UNITED STATES PATENT AND TRADEMARK OFFICE

10/692,468

Office Action Summary	Application No. 10/692,468	Applicant(s) BAO ET AL.	
	Examiner JOSHUA LEVINE	Art Unit 3774

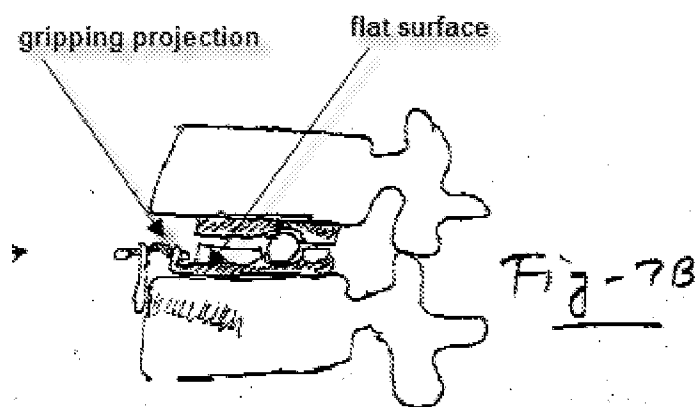
Ferree (PG Pub no. 20030204260) teaches shells (intradiscal device; figure 7B) that

includes a gripping projection (see annotated figure 7B) integral with the body of the one shell configured to allow a separate tool to grip around the projection for tool insertion of the shells through the annulus incision into the intervertebral space and shifting of the shells (controlled range of motion (paragraph 41) wherein the gripping projection comprises a gripping post of the at least one of the upper and lower shells that projects from the one shell toward the other of the upper and lower shells (see annotated figure 9) and wherein the gripping projection includes an arcuate engagement surface for rotating the one shell with the tool (via swivel feature; paragraph 42, figure 6) and a generally flat abutment surface (via anterior portion; paragraph 43) for locking the one shell against rotation with the tool. It would have been obvious to one of ordinary skill in the art at the time of the invention to include the grip projection with an arcuate engagement surface and flat abutment surface for the purpose of providing an intradiscal device with the ability to self center while remaining safely inside the annulus (paragraph 14).

17. Regarding claim 26, Ferree teaches wherein the flat surface portion of one of the shell bodies includes an integral gripping post projecting away therefrom (see annotated figure 7B).
